Subject: Transmittal of Revision 2 to Service Bulletin No. V2500-ENG-71-0051

**V2500-ENG-71-0051**

ENGINE - INTRODUCTION OF CHANGES TO ENGINE DRESSING CLEARANCES

V2500-A1

Clipping arrangements (Part 1)  
Figure 1

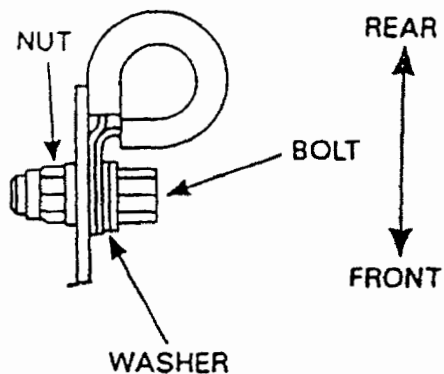
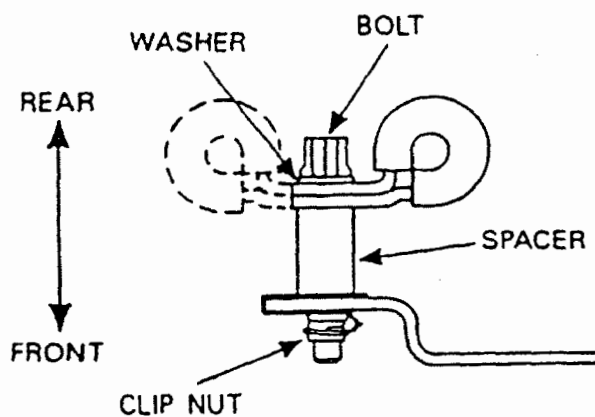
- (i) The minimum clearance between the electrical harness, tubes and other hardware should be 0.100 inches (2,54 mm).
- R (ii) Clip CP0831 is transferred from the outboard to the inboard side of the bracket.
- R (iii) Clip CP5690 is rotated through 180 degrees and is now facing inboard.

R (b) CP0831, (Refer to figure 1 and Engine Manual, TASK 72-00-32-420-004)

R (i) Reposition the clip from outboard to inboard side of the bracket.

R (ii) Torque the nut/bolt to 36 to 45 lbf.in. (4 to 5 Nm).

R (c) CP5690, (Refer to figure 1 and Engine Manual, TASK 72-00-40-420-006)

R (i) Reposition the clip on the harness and refit to the bracket 180 degrees from old position.

R (ii) Torque bolt to 36 to 45 lbf.in. (4 to 5 Nm).

Clipping arrangements (Part 3)

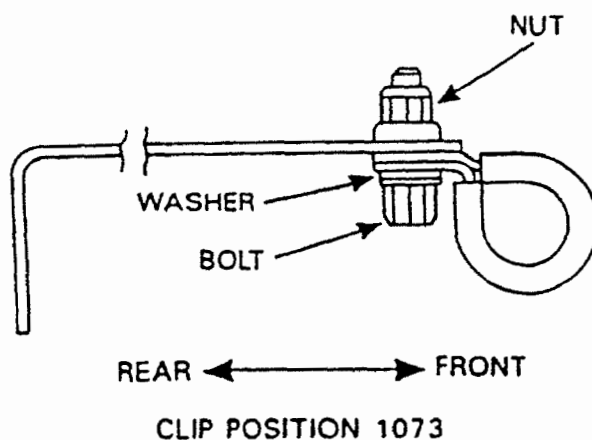
R (i) Clip CP1073 is transferred from the outboard to the inboard side of the bracket.

- R (iii) Torque the nut/bolt to 36 to 45 lbf./in. (4 to 5 Nm).
- R (3). Part 3
- R (a) CP1073, (Refer to figure 2 and Engine Manual, TASK 72-00-32-420-003)

- R (i) Reposition the clip on the tube.
- R (ii) Reposition the clip from outboard to inboard side of the bracket.
- R (iii) Torque the nut/bolt to 36 to 45 lbf./in. (4 to 5 Nm).

Clipping arrangements (Part 3)  
Figure 3

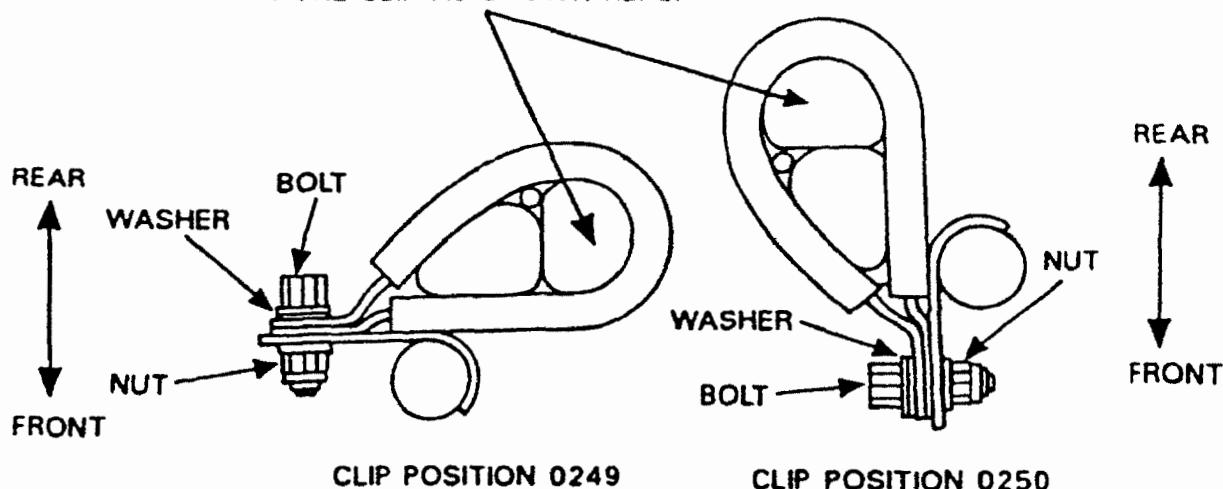
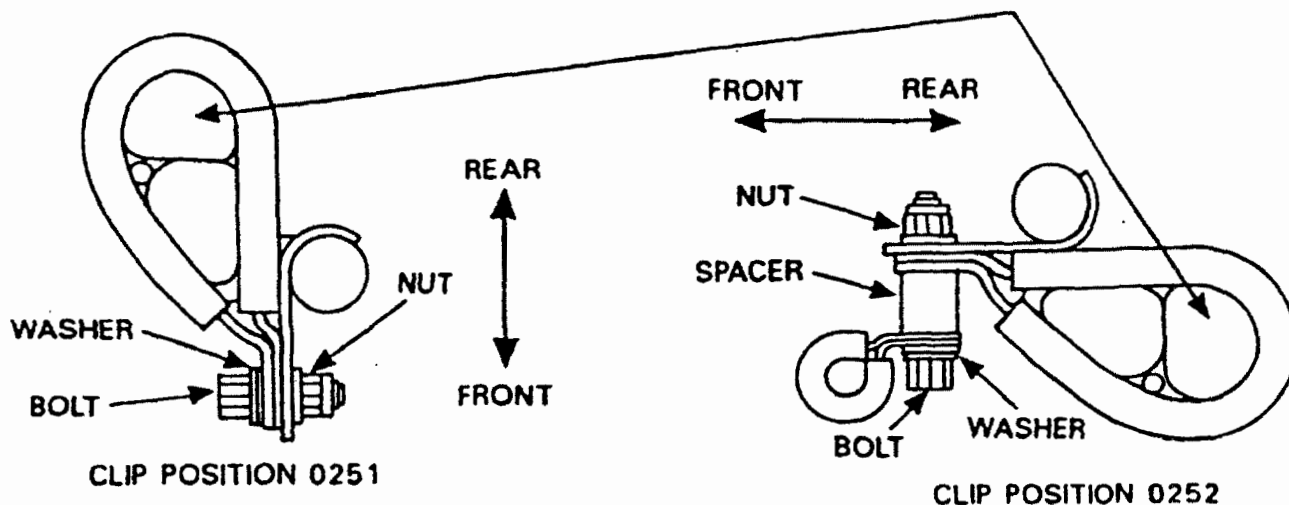
R (iii) The positions of the individual harness within the clips are specified and the clips CP0249, CP0250, CP0251 and CP0252 are slightly reshaped.

THIS BUNDLE GOES TO PLUG  
4008VC - A ON THE BIFURCATION  
PANEL AND MUST BE POSITIONED  
IN THE CLIP AS SHOWN HERE.

THIS BUNDLE GOES TO PLUG  
4008VC - A ON THE BIFURCATION  
PANEL AND MUST BE POSITIONED  
IN THE CLIP AS SHOWN HERE

- R (b) CP0249, CP0250 and CP0251, (Refer to figure 3 and Engine Manual TASK 72-00-32-420-004). CP0252, (Refer to figure 3 and Engine Manual TASK 72-00-60-420-003).

- R (i) Disconnect clips.
- R (ii) Re-shape the clips and position the harness bundles side by side, as shown in figure 3.
- R (iii) Refit the clips and torque the nuts/bolts to 36 to 45 lbf./in. (4 to 5 Nm).
